D3041-1 & D3041-3 CLAMPS

COPYRIGHT © 2001 BY DART AEROSPACE USA, INC. THIS DOCUMENT IS PRIVATE AND CONFIDENTIAL AND IS SUPPLIED ON THE EXPRESS CONDITION THAT IT IS NOT TO BE USED FOR ANY PURPOSE UNAUTHORIZED BY DART AEROSPACE USA, INC. COMMUNICATED OR REPRODUCED WITHOUT PERMISSION FROM DART AEROSPACE USA, INC.		A DESIGN	01.06.28	NEW ISSUE	DART DART AEROSPACE USA, INC. PORT HADLOCK, WA	REV. A SHEET 1 OF 1	SCALE 1:1
CHECKED 	APPROVED 	DRAWN BY 	01.06.28	DRAWING NO. D3041	TITLE CLAMP	DATE 01.06.28

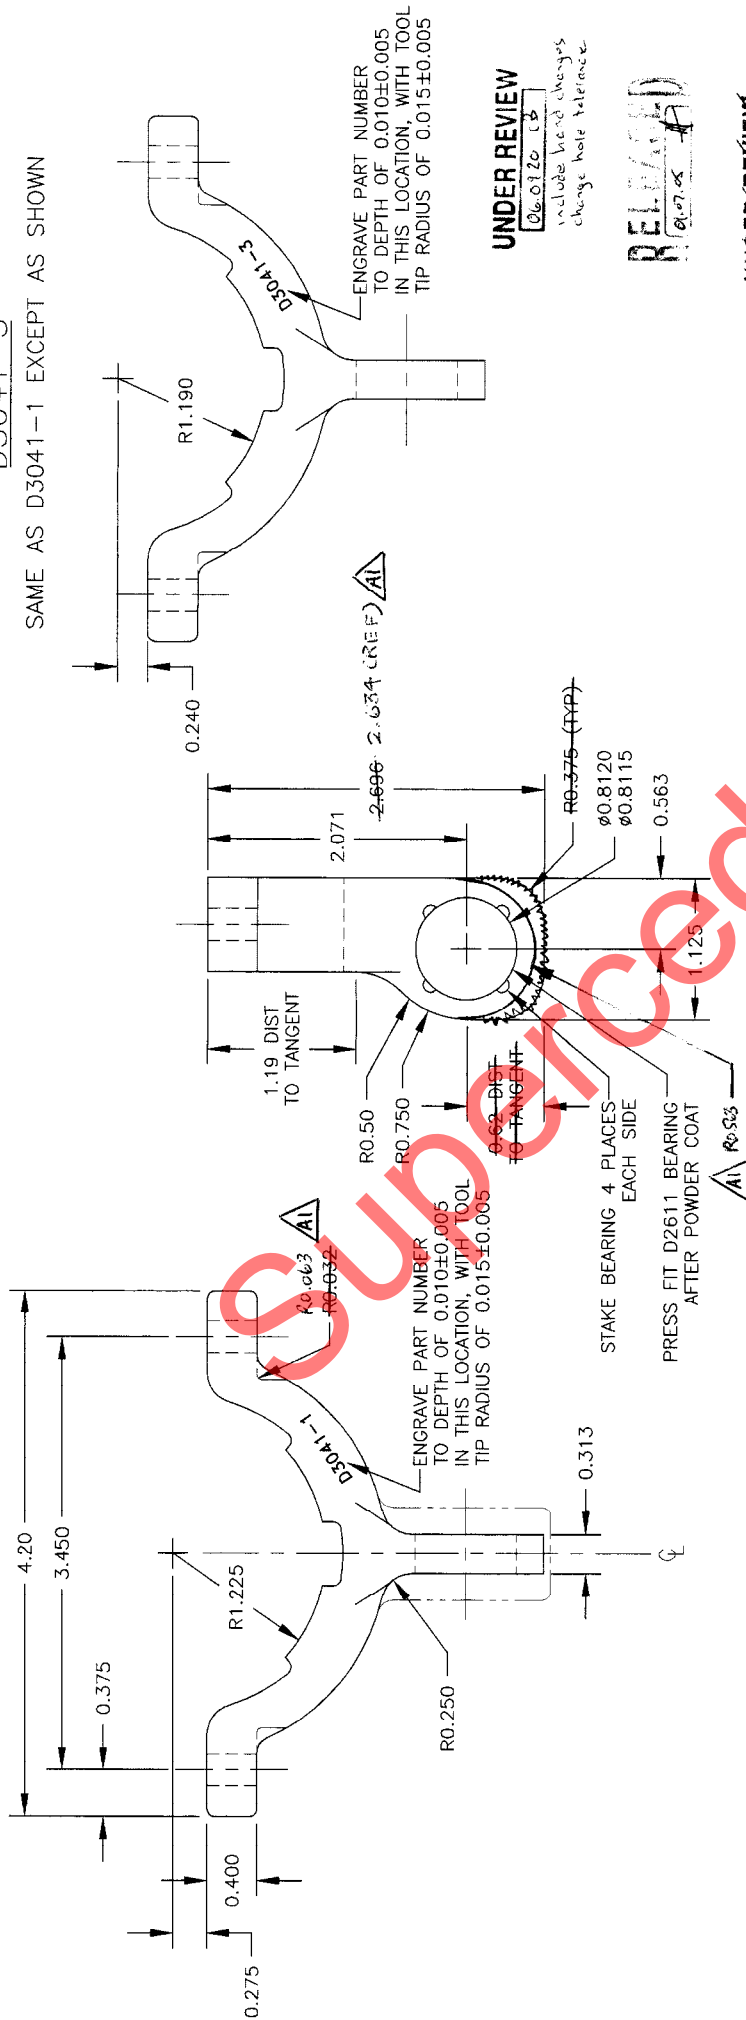
06.0920 CB include hand changes
change hole tolerance

# CP	01.04.06	CHANGE TO ROUND END DETAIL R.O.063 W.A'S R.O.032
------	----------	---
